**RESPONSES TO THE OHIO ENVIRONMENTAL PROTECTION AGENCY COMMENTS AND  
UNITED STATES ENVIRONMENTAL PROTECTION AGENCY DISAPPROVAL OF THE  
DESIGN FOR REMEDIATION OF THE GREAT MIAMI AQUIFER SOUTH FIELD PHASE II  
MODULE**

**RESPONSES TO OEPA COMMENTS ON THE  
DESIGN FOR REMEDIATION OF THE GREAT MIAMI AQUIFER  
SOUTH FIELD PHASE II MODULE**

**FERNALD ENVIRONMENTAL MANAGEMENT PROJECT  
FERNALD, OHIO**

**OCTOBER 2002**

FIGURE 1. NON-RETARDED PARTICLE TRACKS SEEDS AT 510 FEET AMSL WITH INITIAL TOTAL URANIUM CONCENTRATIONS IN VAM3D ZOOM MODEL LAYER 12

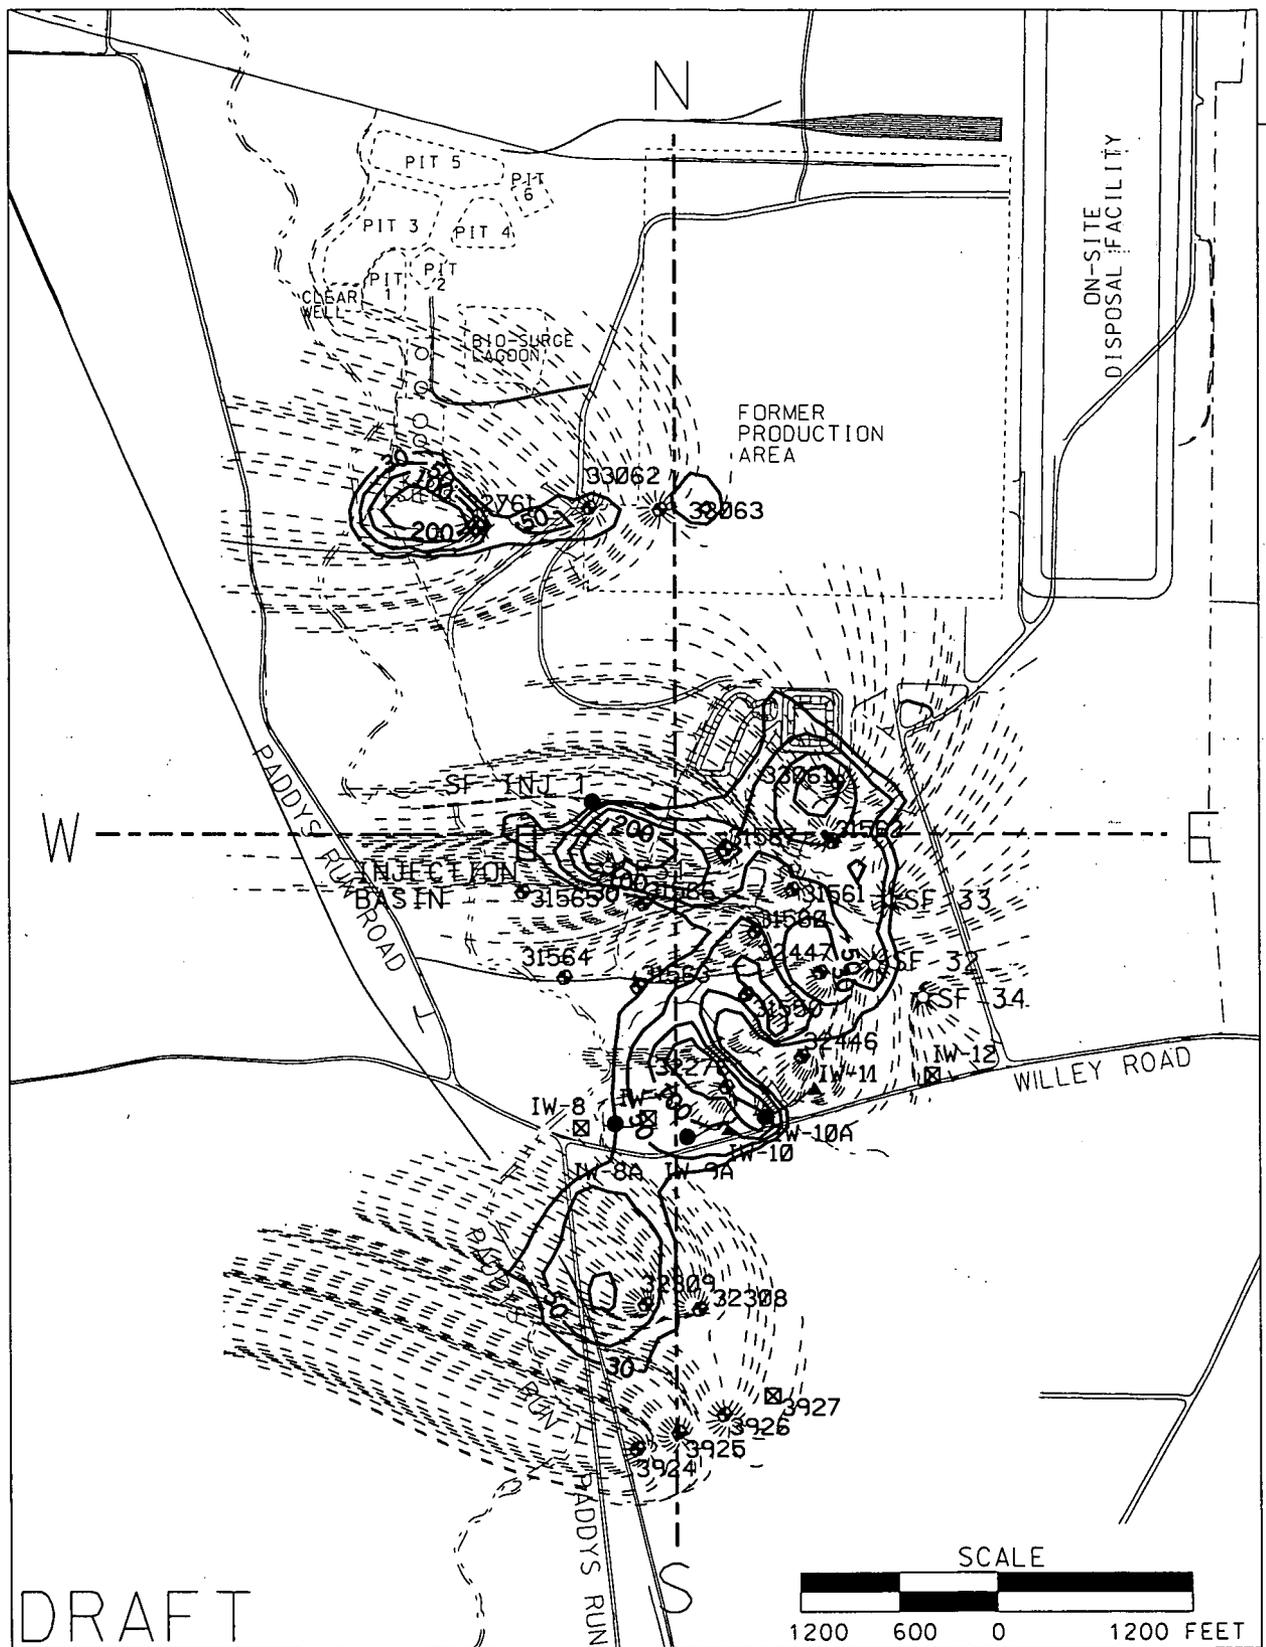
Comment: A useful addition to the report would be a figure showing the un-retarded particle tracking results shown in relation to the total plume footprint. Also, a figure showing the un-retarded particle tracking results for a selected cross section is also recommended. These figures would provide an indication of the overall capture zone for the design. The six-year retarded particle tracks shown on the figures referenced in Section 3.4.3 are potentially misleading because they are subject to uncertainties regarding the proper partitioning coefficient that is appropriate for the cleanup time frame.

Response: Attached Figure 1 shows the non-retarded particle tracking results superimposed onto the total uranium plume footprint as requested in the comment. The particle tracks are taken from Figure 3-10 of the design report and the uranium concentration contours are initial total uranium concentrations in model layer 12 from Figure 3-20 of the design report. Figures 2 and 3 (attached) show non-retarded particle tracking results superimposed with two selected cross sections of the modeled uranium plume sliced at 1983 Northing coordinate of 478,000 in Figure 2 and sliced at 1983 Easting coordinate of 1348550 in Figure 3. The cross section locations are represented on Figure 1 for reference.

DOE agrees that the six-year retarded particle tracks shown on the figures referenced in Section 3.4.3 are potentially misleading in that they represent a 12 to 1 retardation of uranium with respect to groundwater flow. The 12 to 1 ratio is directly related to the linear equilibrium isotherm Kd value of 1.78 L/Kg. A smaller Kd value would give a smaller retardation value resulting in longer retarded particle tracks. Conversely, a larger Kd value would give a higher retardation value and shorter retarded particle tracks.

Figure 4. Total Uranium Data - Semi-Variograms

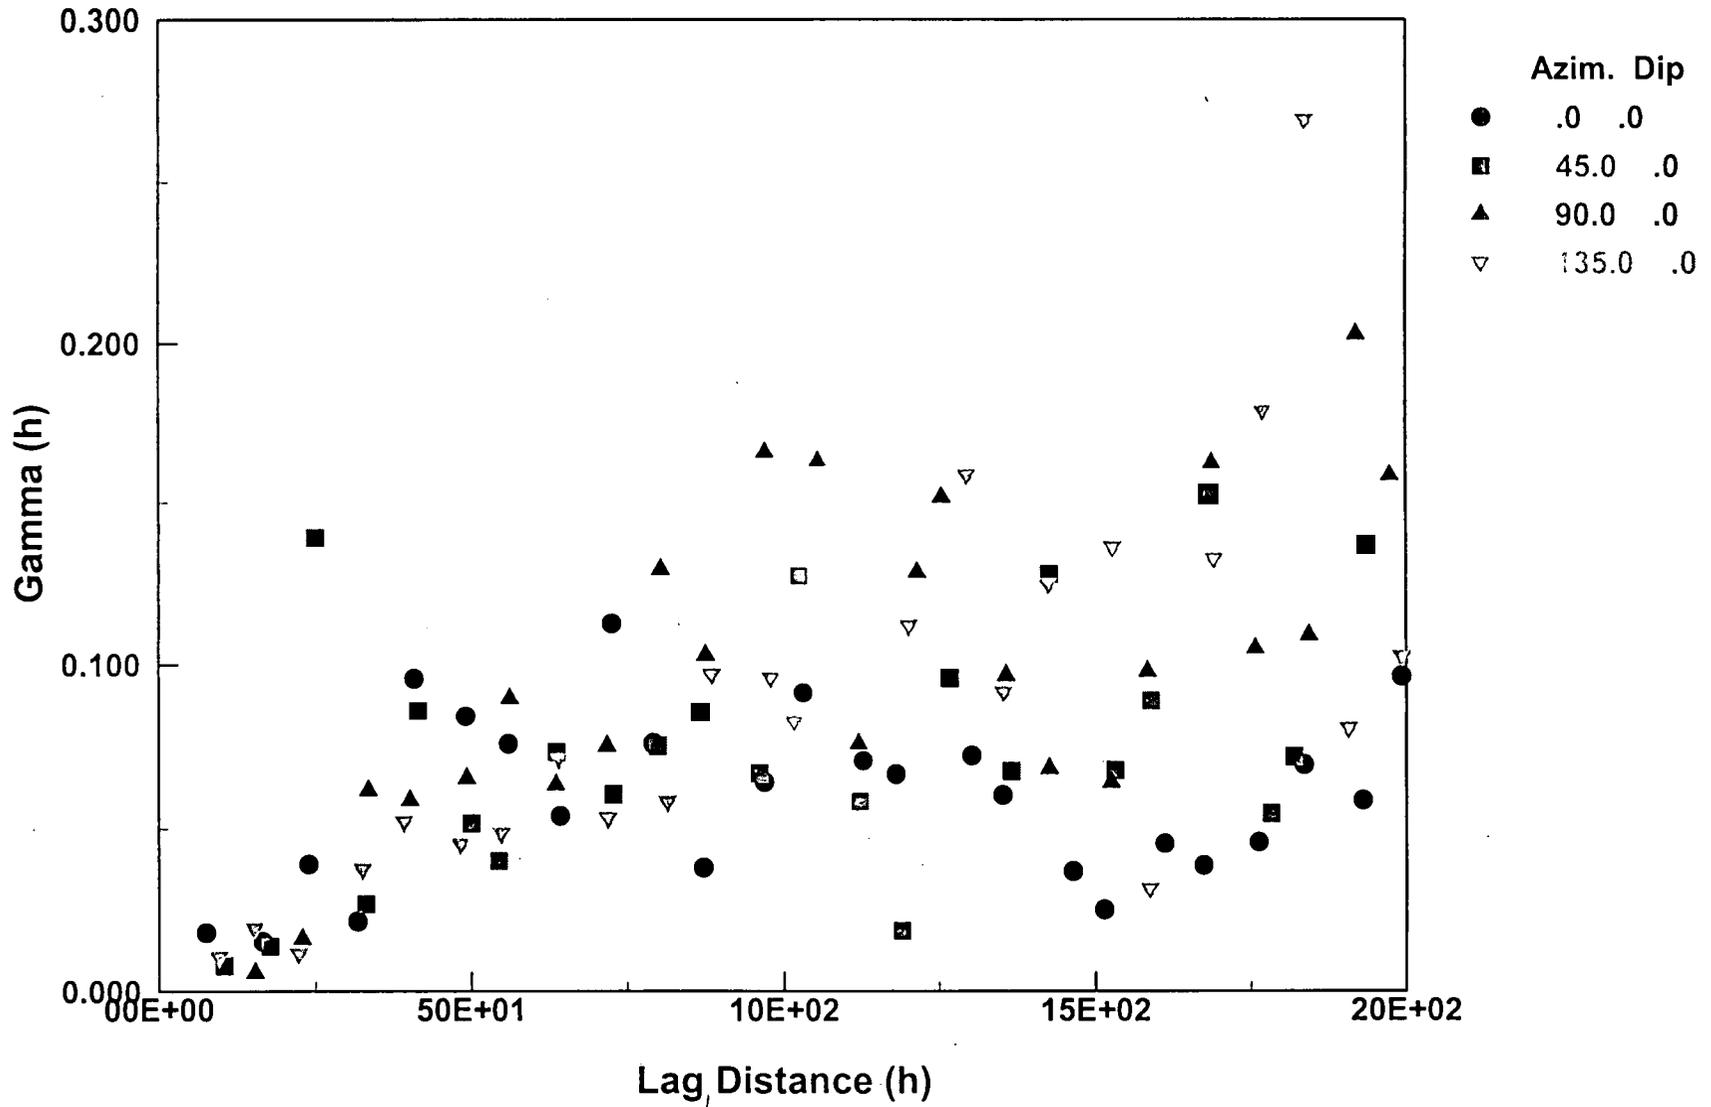
Comment: The report should provide discussion and justification for use of the variogram parameters for the current data set. The current concentration data set differs significantly in detail from the data set kriged in the referenced 1994 document because of the addition of the substantial amount of drive point data. The current data set more closely resembles data set evaluated for the conceptual design for groundwater remediation in the waste storage and Plant 6 areas. The variogram ranges for the current analysis differs significantly from those used previously (3000 vs. 500 feet for horizontal; 60 vs. 25 feet for vertical, respectively). The use of the dataset-specific geostatistical analysis for the waste storage and Plant 6 areas design is more appropriate than simply adopting variography previously developed for a more limited site wide data set.

Response: DOE agrees that a semi-variogram range derived from a dataset-specific geostatistical analysis would have been more appropriate to use in Kriging the total uranium data to generate initial conditions for the transport model. However, Kriging results do not appear to be sensitive to the Kriging range if the Kriging range is larger than the semi-variogram range. As demonstrated in the semi-variograms generated from the total uranium data and shown in Figure 4 (attached), the horizontal semi-variogram range appears to be approximately 1000 feet which is smaller than the 3000 foot Kriging range used in the report. The 3000 foot range was used for consistency with the 1994 modeling report. Figures 5 through 9 show the initial conditions for model layers 9 through 13 when the data is Kriged with a 1000/50 foot horizontal/vertical range instead of the 3000/120 foot horizontal/vertical range.

FIGURE 11. NON-RETARDED 6 YEAR PARTICLE TRACKS SEEDED AROUND EXTRACTION WELLS AT DIFFERENT INITIAL DEPTHS

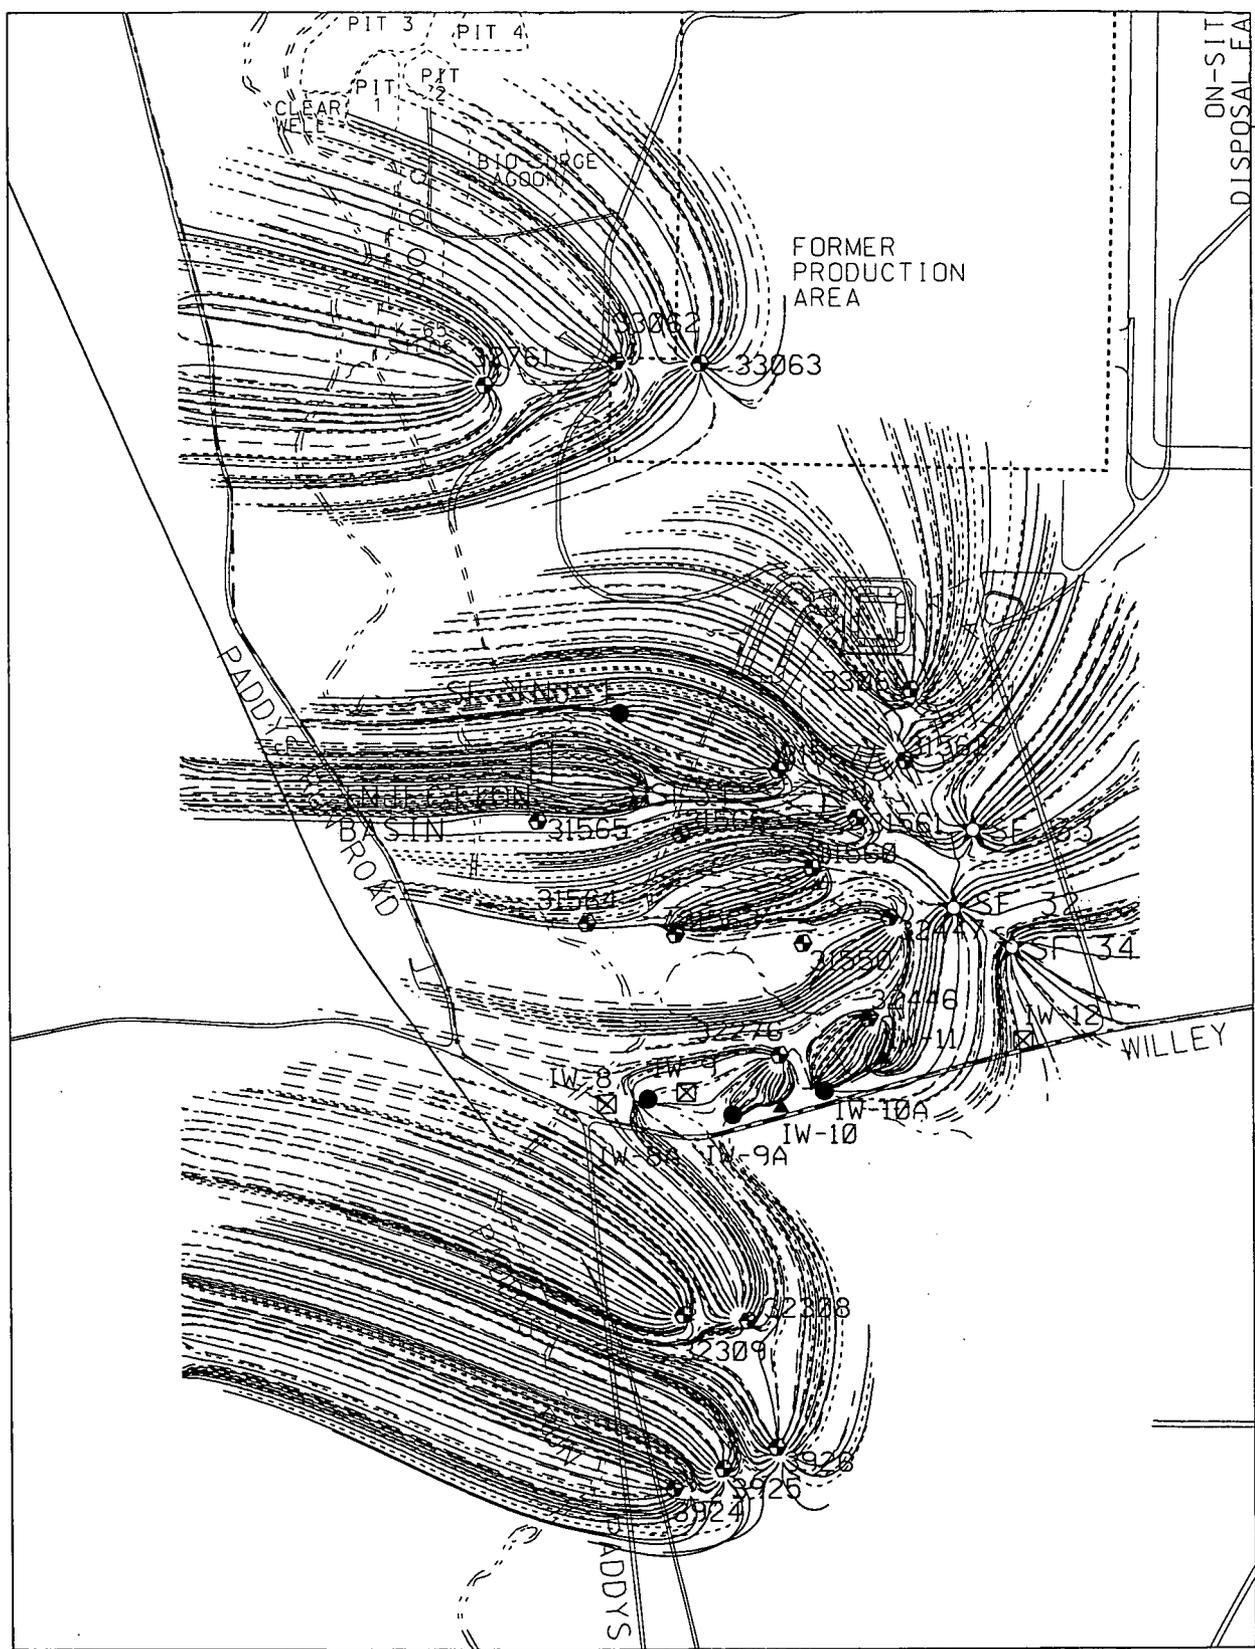
Comment: Figures 22 through 26 show the particle tracking results for each model layer. The particle tracks appear to be identical from layer to layer. Some of the extraction wells, however, are not completed in every layer. At least some differences in the tracks, thus, would be expected. Are these figures correct?

Response: There are no particle tracks on Figures 3-22 through 3-26. Presumably, the commentor is referring to Figures 3-17 through 3-21 that show retarded particle tracks around each extraction well and initial total uranium concentrations in model layers 9 through 13 inclusive. Particle tracking is performed with TecPlot, a third party software package from Amtec Engineering. Therefore, particles are not seeded according to model layers since the TecPlot software uses only the VAM3D output velocity field and not model geometry.

The particle tracks in Figures 3-17 through 3-21 are identical in each figure and result from seeding particles at a constant elevation of 510 feet above mean sea level (AMSL) at a radius of 100 feet around each extraction well. Figure 11 attached shows the results of seeding particles at 510, 500, and 490 feet AMSL around each extraction well for comparison. These tracks are not retarded in order to demonstrate that particle paths are relatively insensitive to initial elevation or model layer.
